# 3.0 Gray's Inn Road Facade

## Approved Planning Scheme

## S73 Proposal

S73 Proposal | Partial Section Through Brian Yard

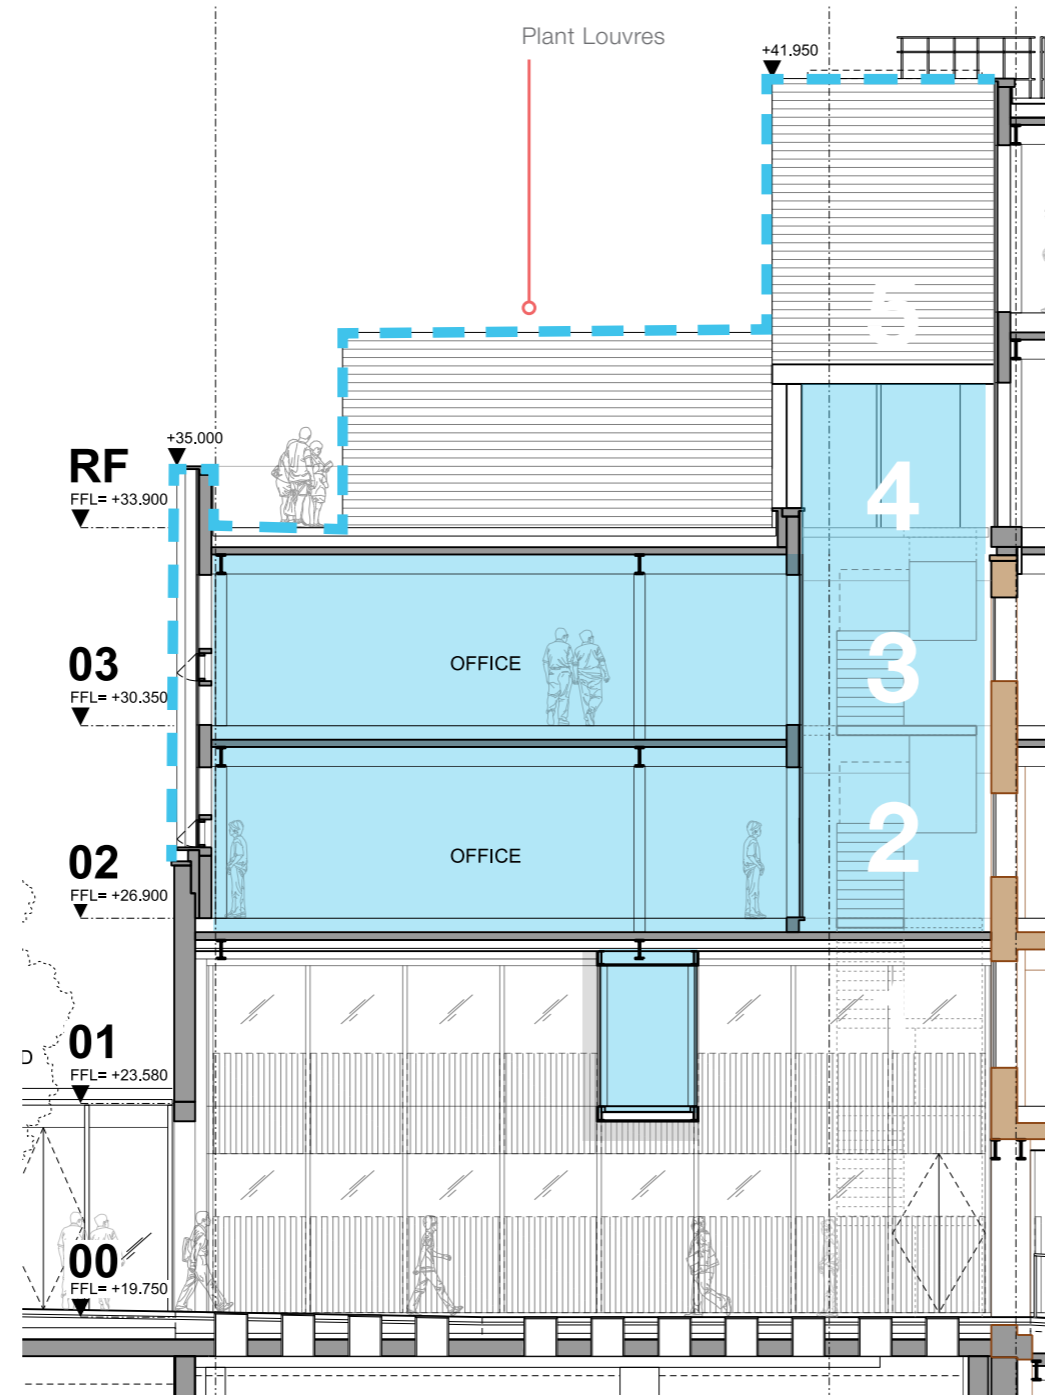
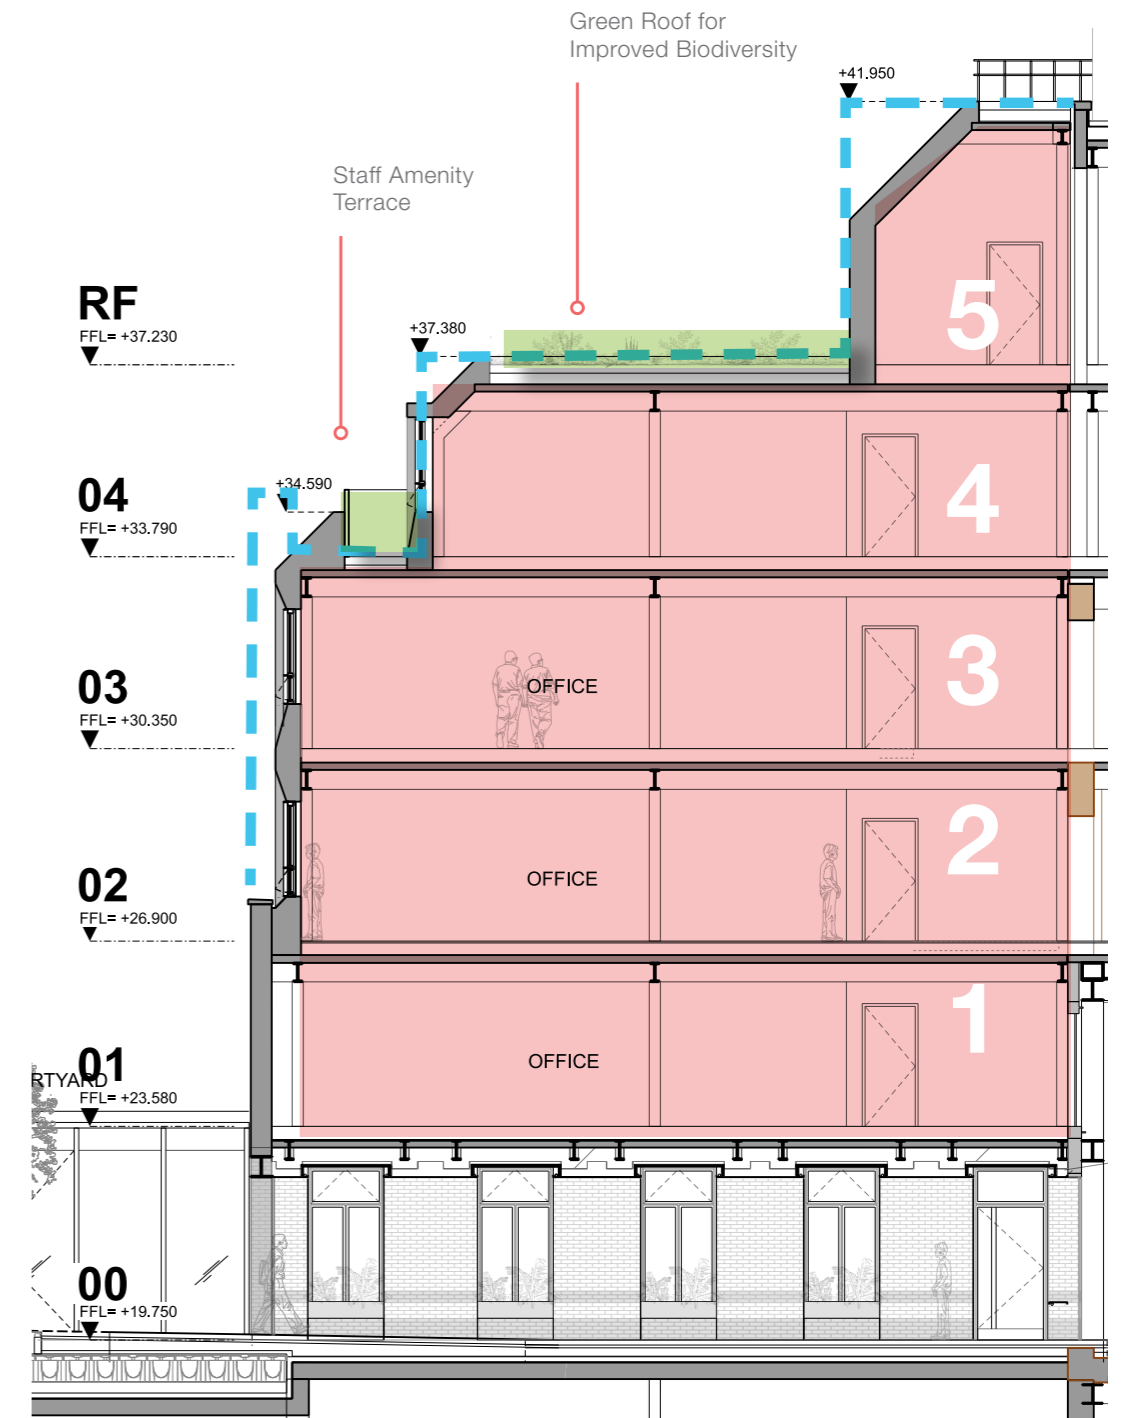
The relocation of plant from the Brain Yard roof to the Panther House building roof unlocks crucial staff amenity terrace space which was previously landlocked around a plant room in the consented scheme.

By changing the use from plant to office space at level 4 a new biodiversity green roof is proposed at level 5 to add to other approved green and brown roofs across the scheme.

2021 S73 Proposal | Partial Elevation

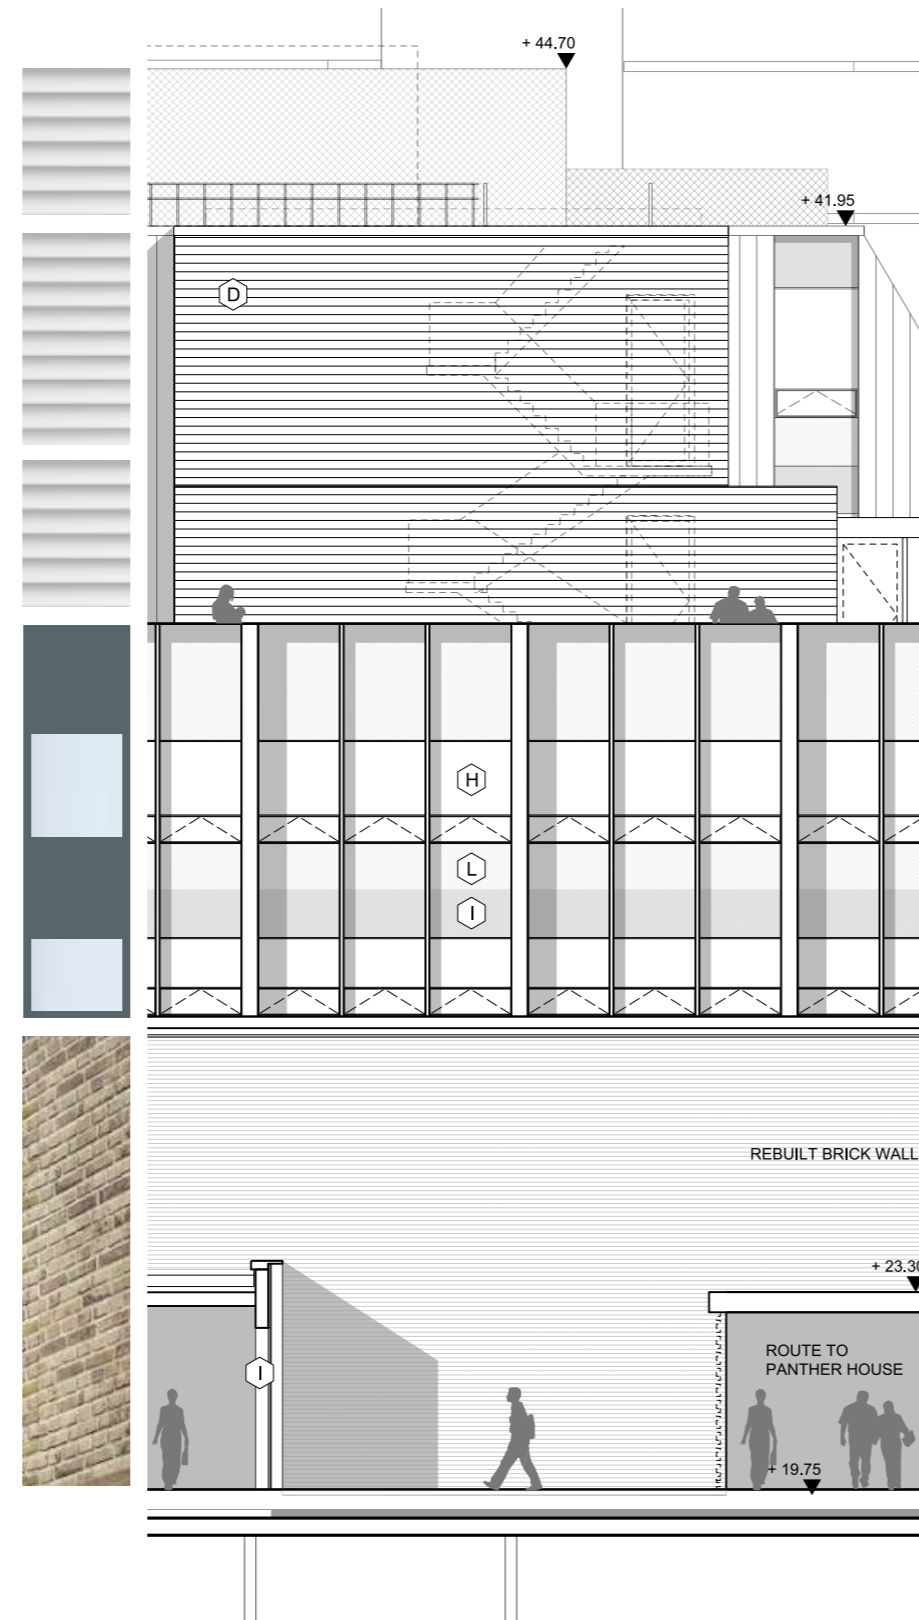
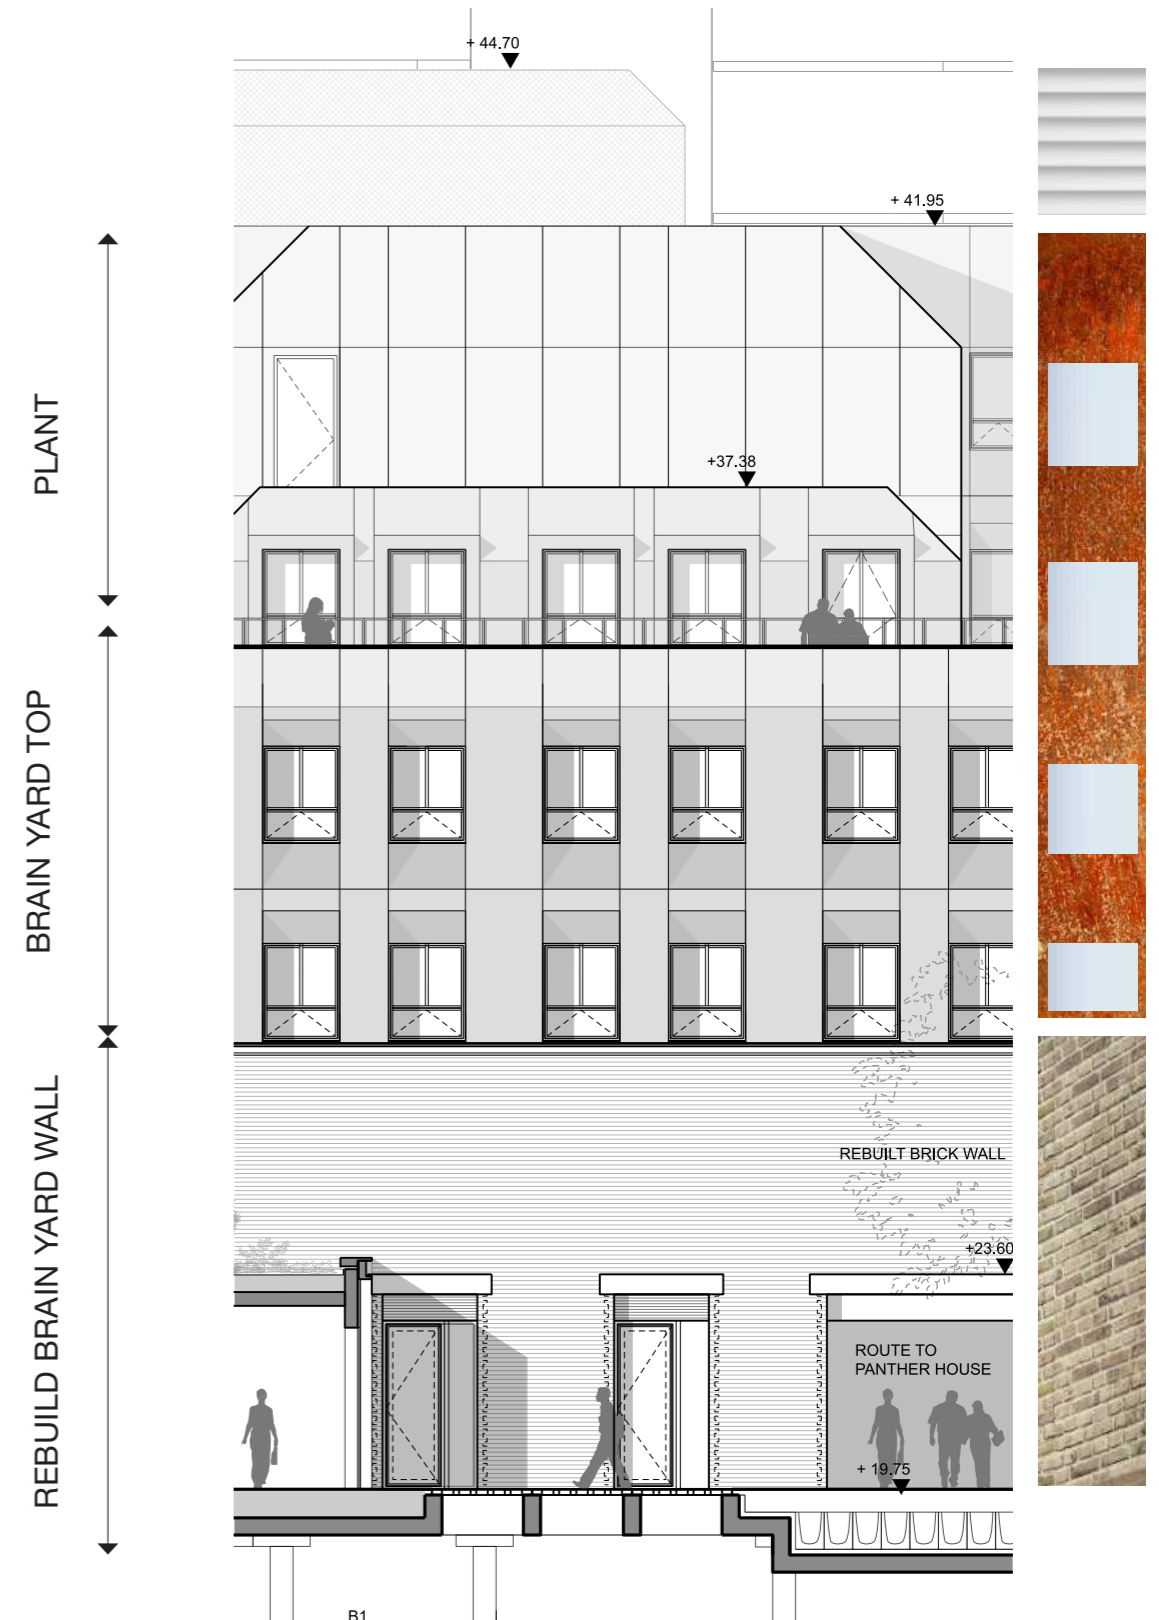
In the approved 2017 scheme the proposed material palette for the new extension building above Brain Yard was a glazed curtain wall box with roof plant louvres.

The current s73 proposal is to reduce the amount of glazing in lieu of punched windows in solid walls. This idea is to make the new extensions read similar to the existing Panther House building.

The introduction of a warm toned weathered steel (or similar) gives the new extensions a better relationship with the existing warehouse 'host' buildings. The new proposed material pallet is more homogeneous across the development.
